Subject: On-Call Asbestos, Lead, Air Quality & Demolition Compliance  
Agreement No. 8.07-01 (18)  
HazMat Inspection – Signage Replacement, Route 9, 15 & SR571 Connector, Cromwell & Berlin, CT  
ConnDOT Assignment No. 519-5849  
ConnDOT Project No. 7-189  
TRC Project No. 289951.5849.0710

**Subject:** Preliminary Design Review Request  
Project No. 0007-0189  
Replacement of Existing Signing on Routes 9  
(MP 24.65 to MP 34.48), 5/15 (MP 68.02 to  
73.40), & SR 571 (MP 00.00 to 01.25)  
Towns of Cromwell and Berlin  
**Date:** October 22, 2018

## PROJECT 7-189 ROUTE 9, 15, & SR 571 HIGHWAY RESIGNING

## Plans For REPLACEMENT OF HIGHWAY SIGNING ON ROUTE 9, 15, & SR 571 CONNECTOR

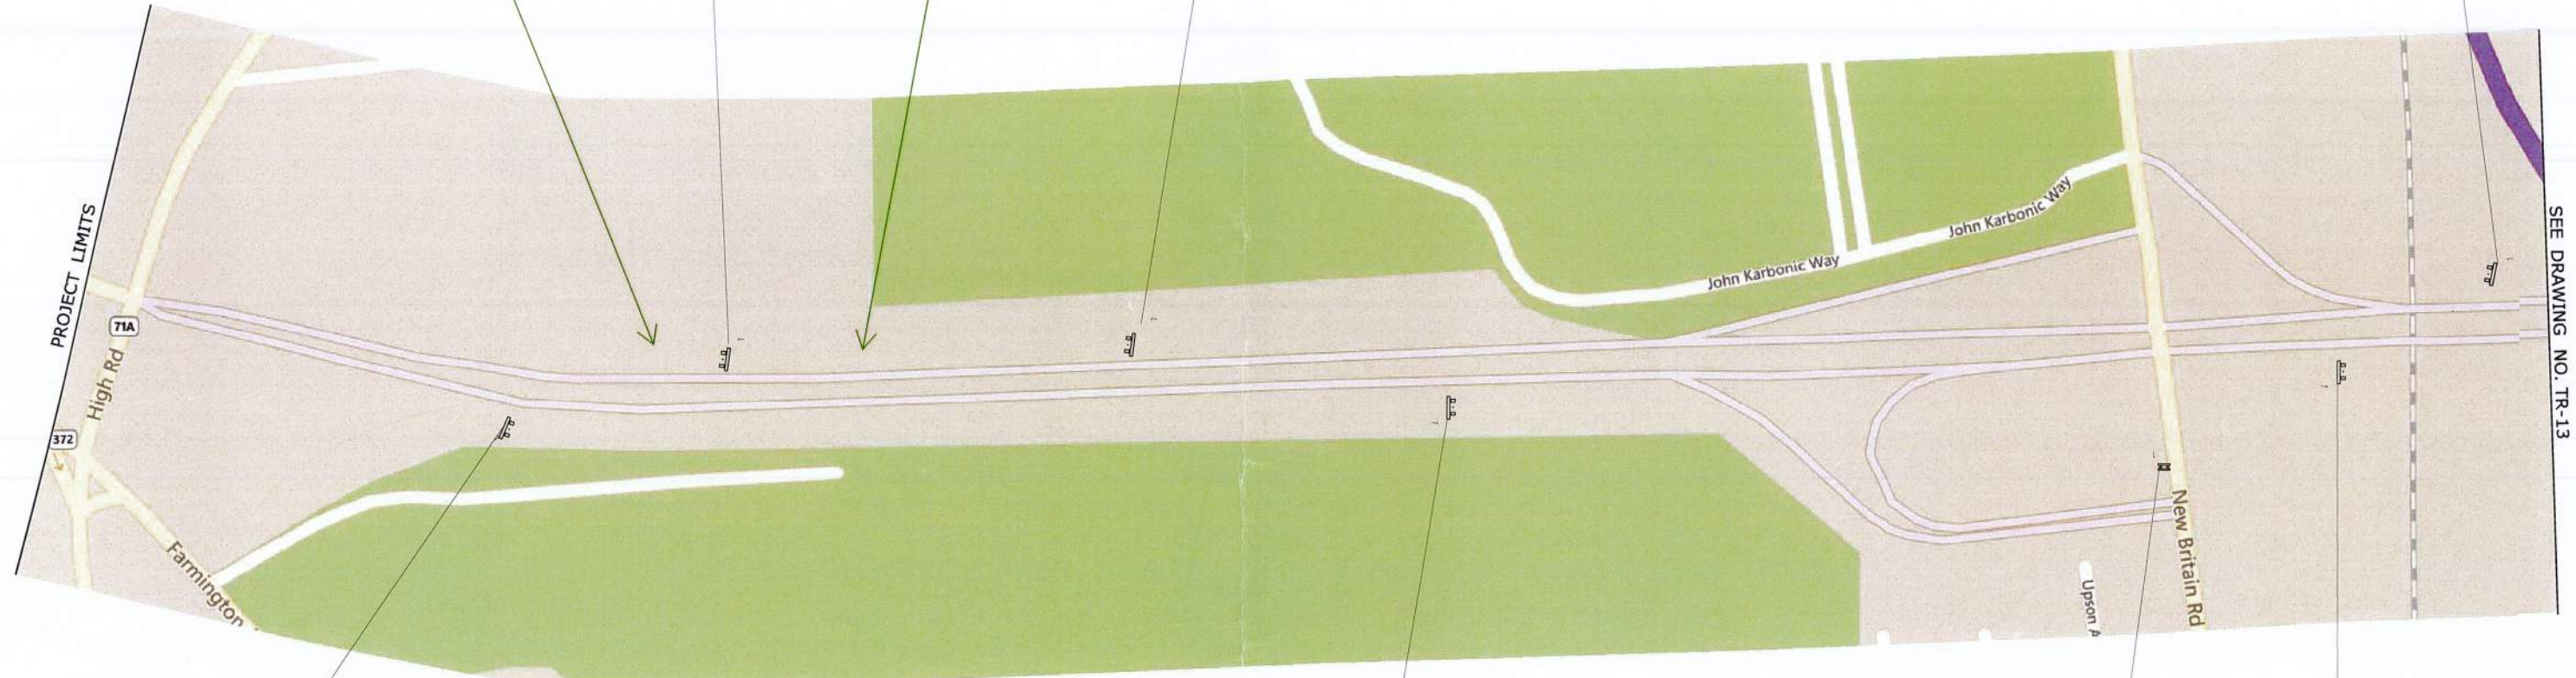
What will happen to the "71A North New Britain Right Lane" sign?

What will happen to the "Signal Ahead 1000 Feet" overhead cantilever sign?

*Galvanized - no paint  
No suspect ACM*

*Galvanized - no paint  
No suspect ACM*

*Galvanized - no paint  
No suspect ACM*

*Galvanized - no paint  
No suspect ACM*

*Galvanized - no paint  
No suspect ACM*

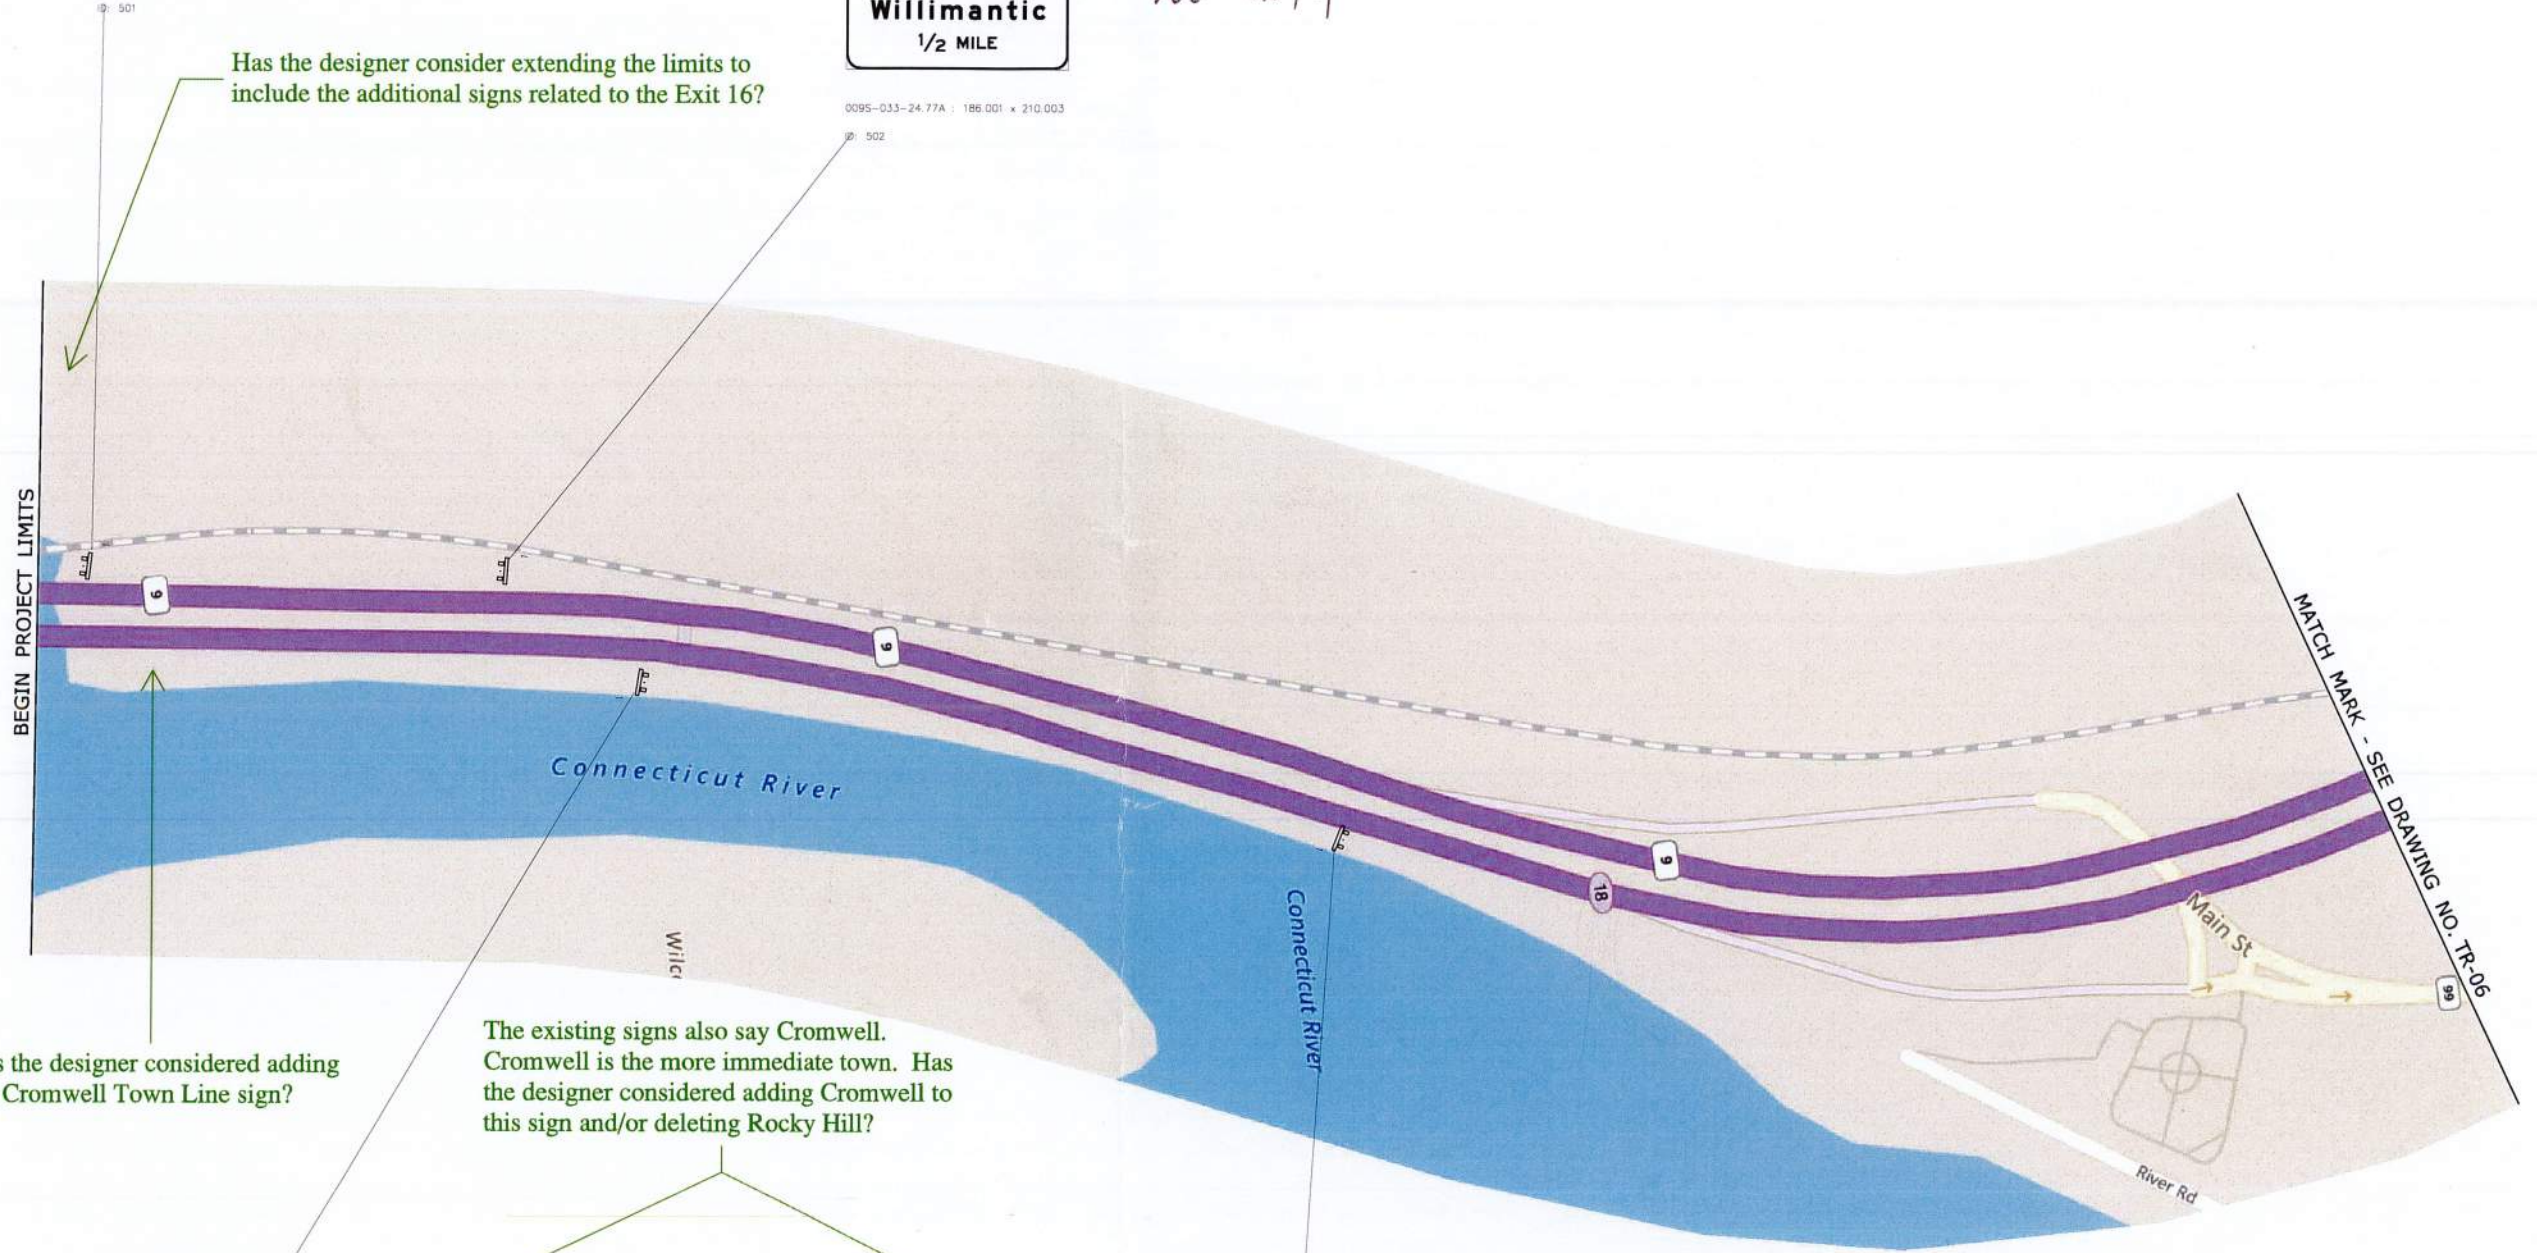
*Galvanized  
No cavity*

*Galvanized  
No cavity*

Has the designer consider extending the limits to include the additional signs related to the Exit 16?

PROJECT NO.  
**0007-0189**  
 DRAWING NO.  
**TR-06**  
 SHEET NO.

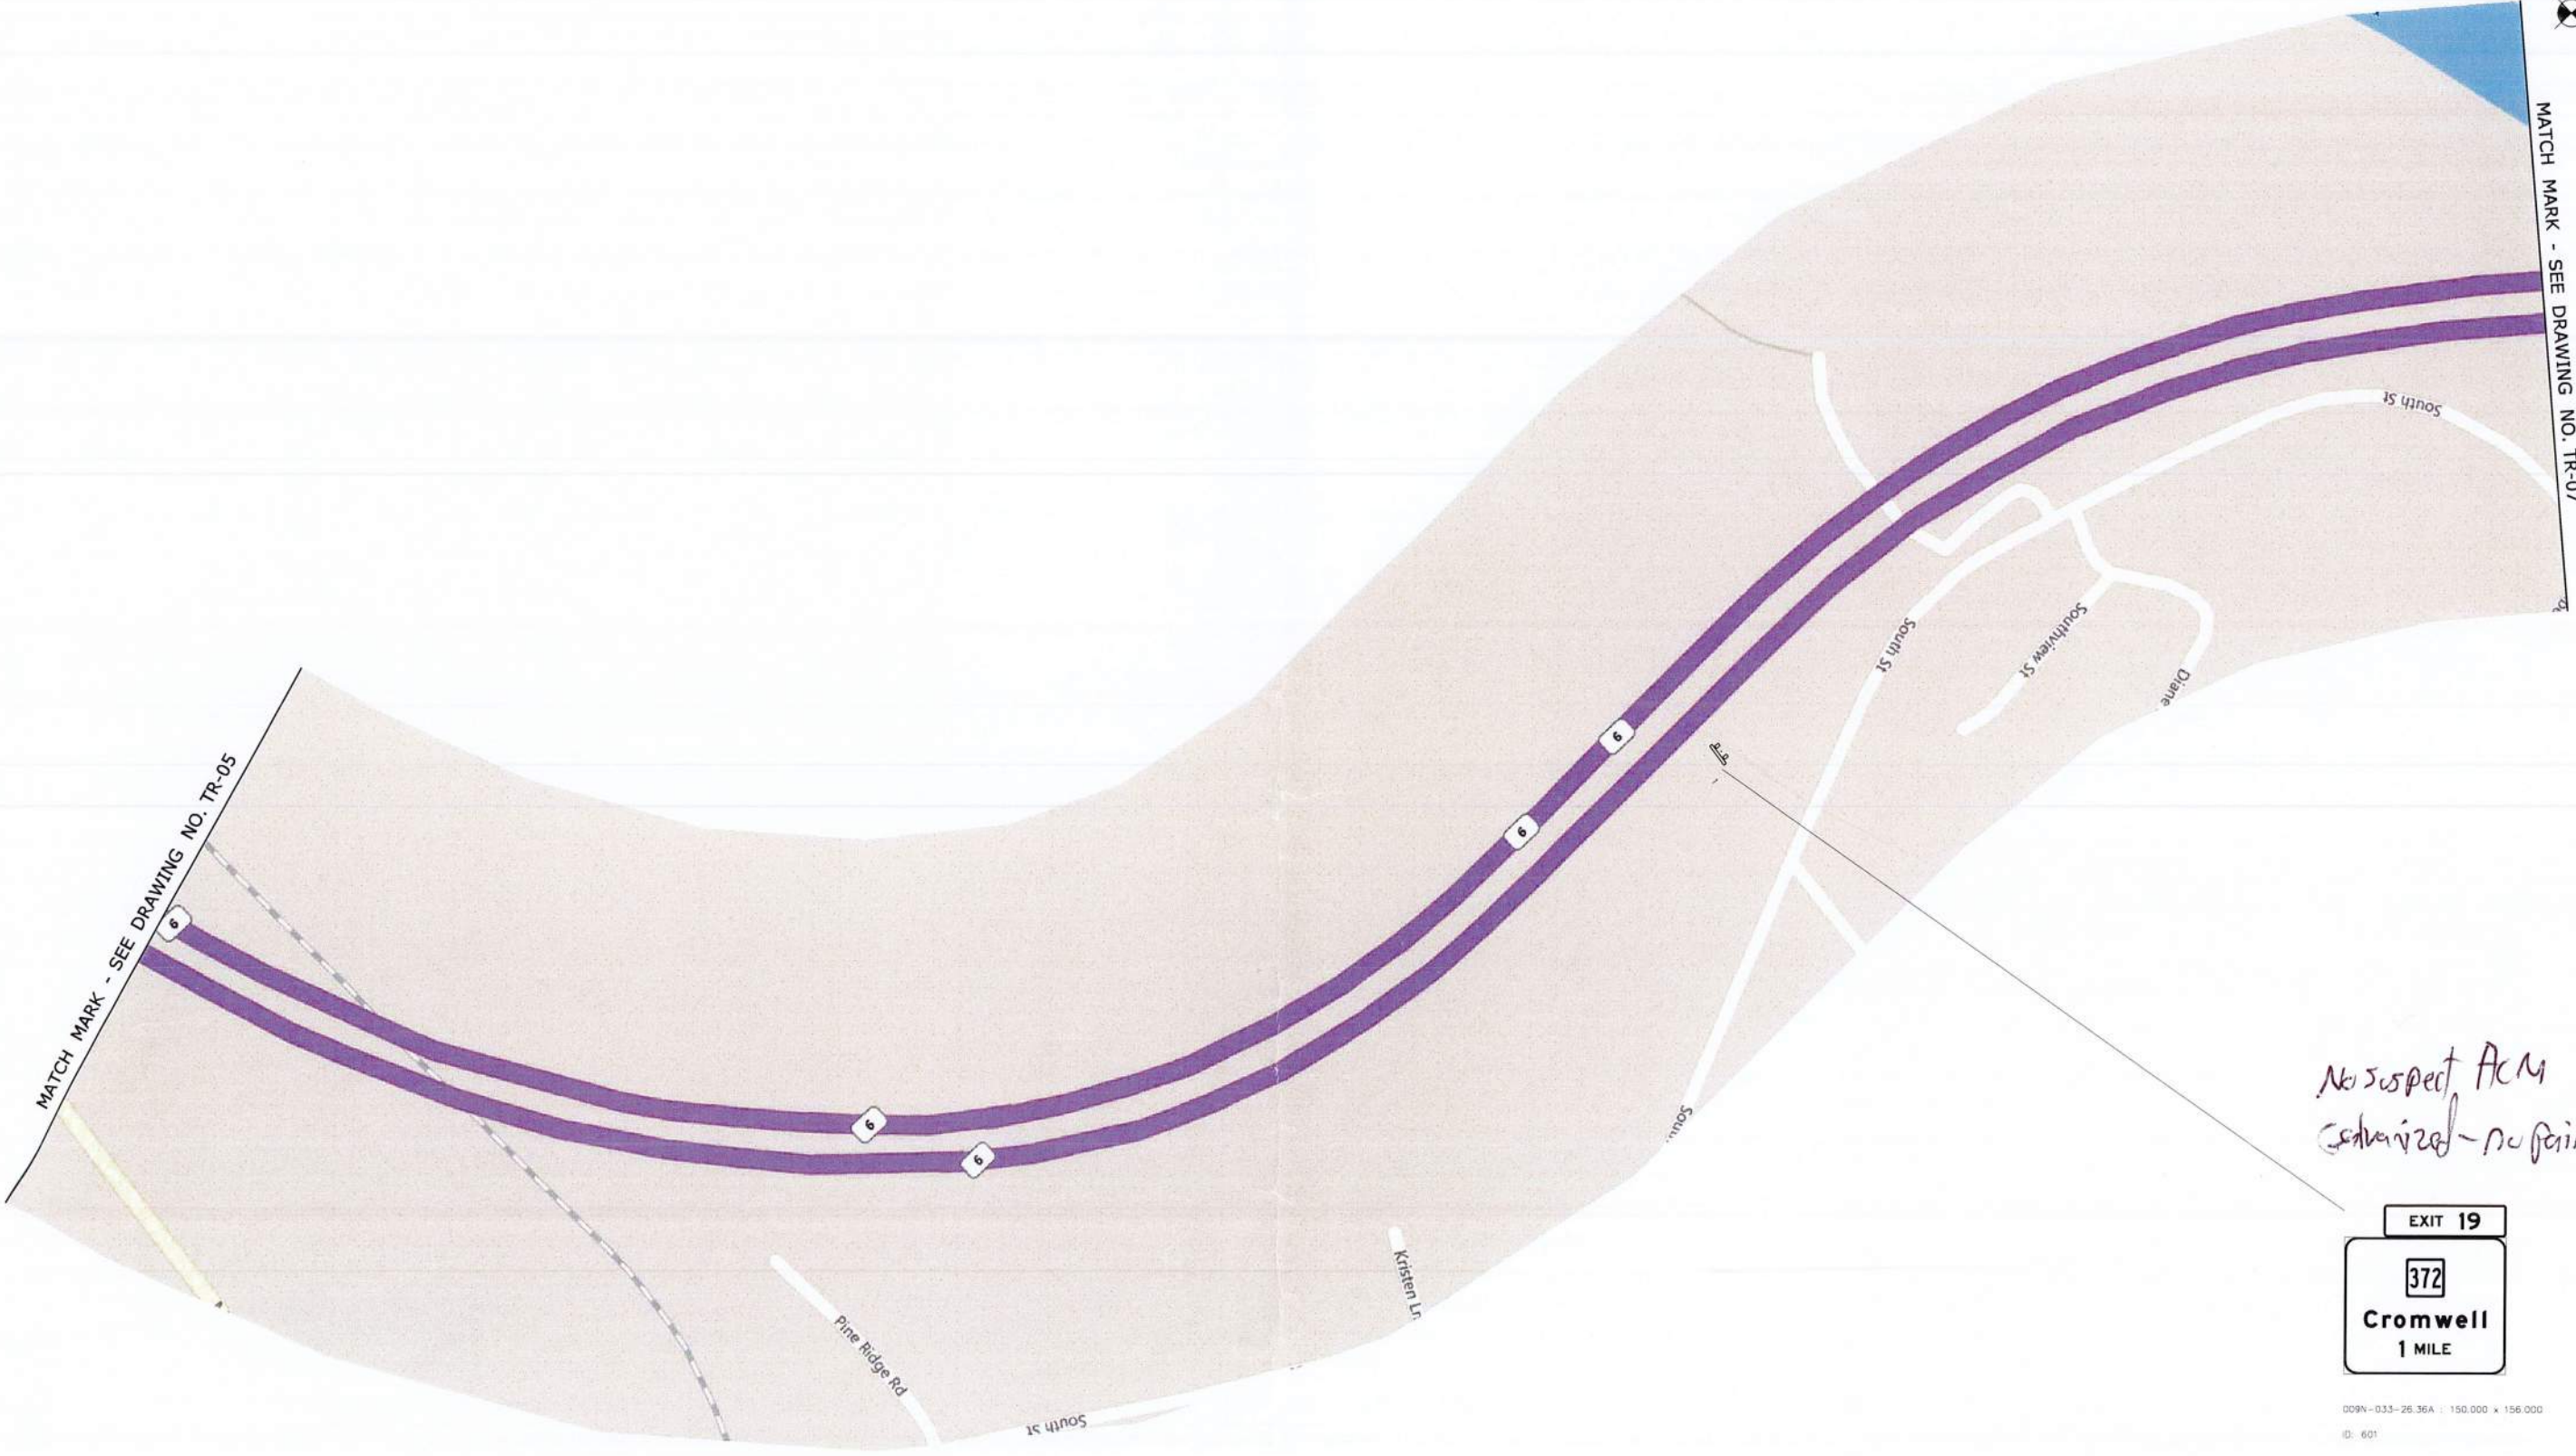
*No suspect ACM advised - no paint*

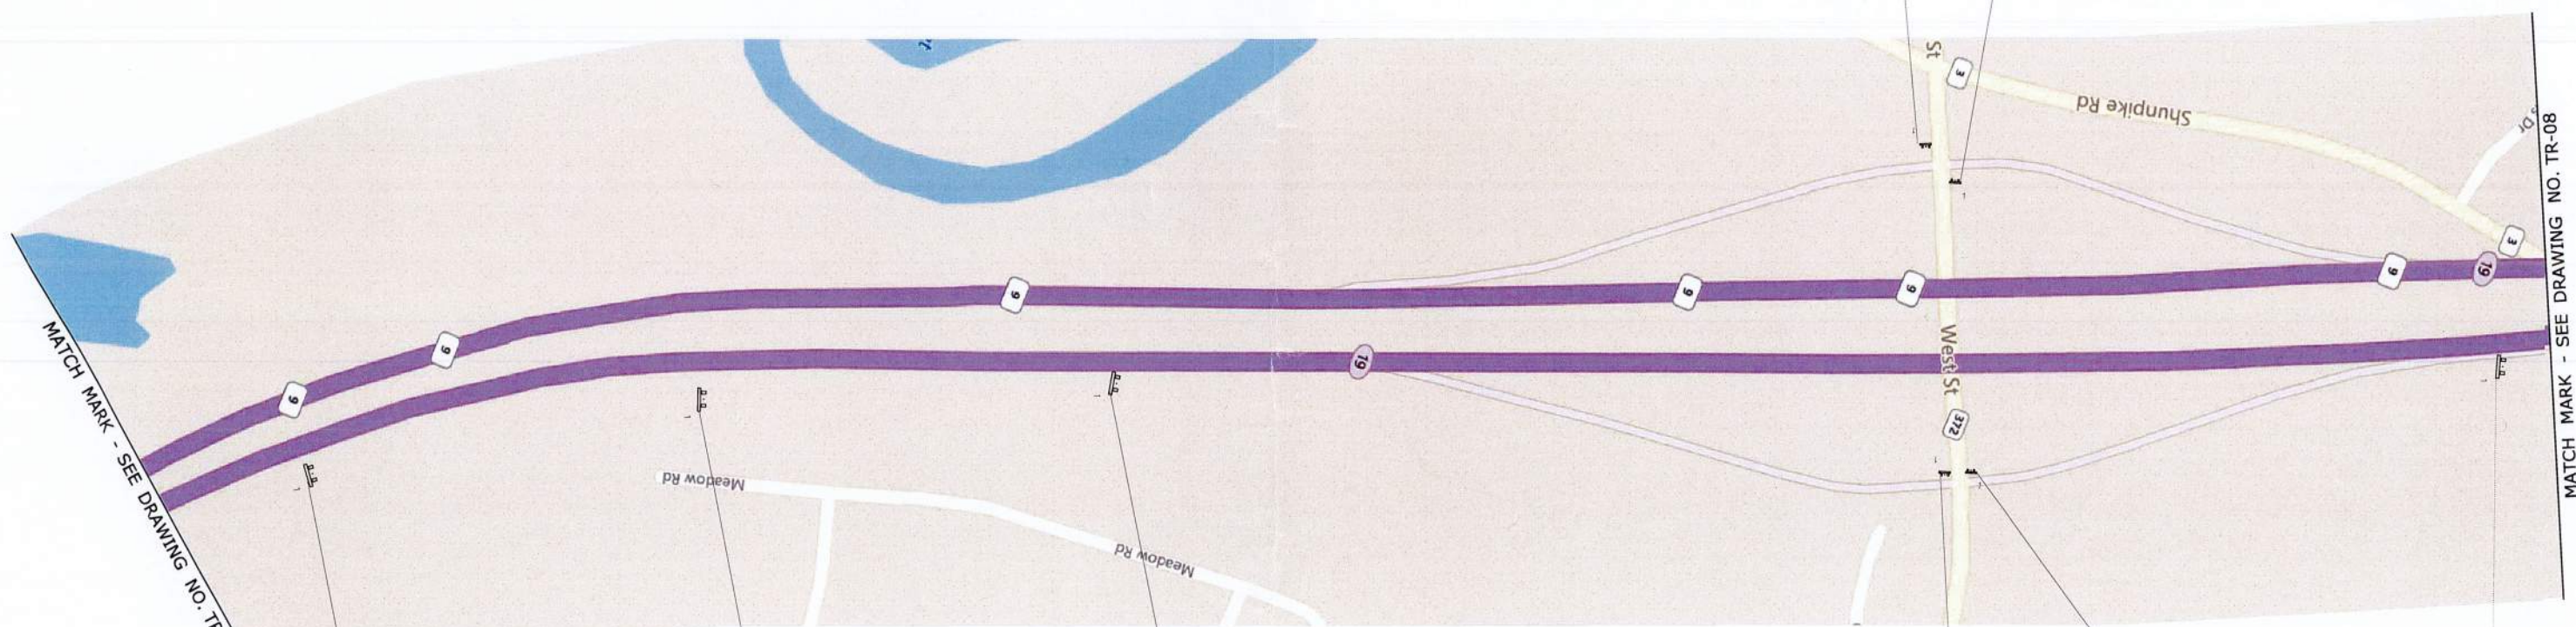
*Galvanized - no paint  
No suspect ACM*
